A 00906

SEWAGE DISPOSAL TESTING

MARYLAND STATE DEPARTMENT OF HEALTH

SUBDIVISION Beaufort Park LOT NO. 7, Bk. B, Pt. 2

INDICATE NORTH. - NAME ADJOINING ROADWAY AS BASE LINE.

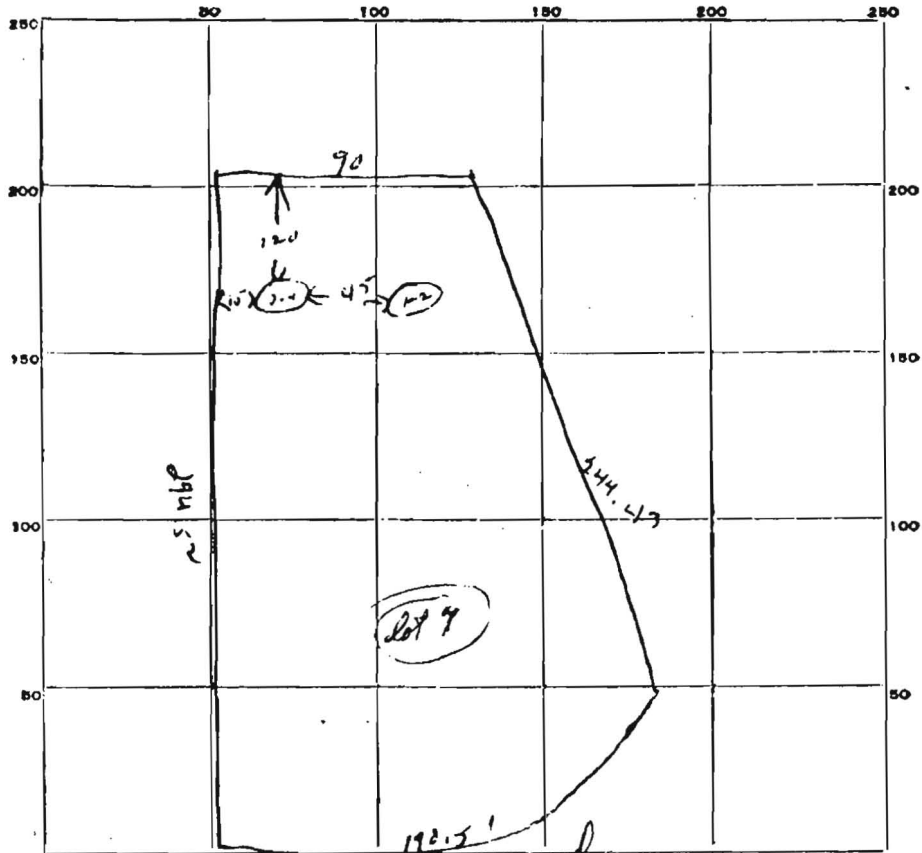
7,121 sq ft
Landscape holes where
dry wells have to be
located to W.M.

Dry Wells - 4 bedroom - two dry wells each 12 ft diameter and 8 ft deep below inlet pipes.
5 bedroom - " " " 13 ft " " and 9 ft " "

both
Place Dry Wells 130 ft from rear lot line with one dry well 20 ft from
left side line and second dry well about 60 ft from left side line as seen when facing
lot from Edenton Rd.

* Dry Wells must be 3x the diameter apart - edge to edge.
and connected in series. No dist. box needed
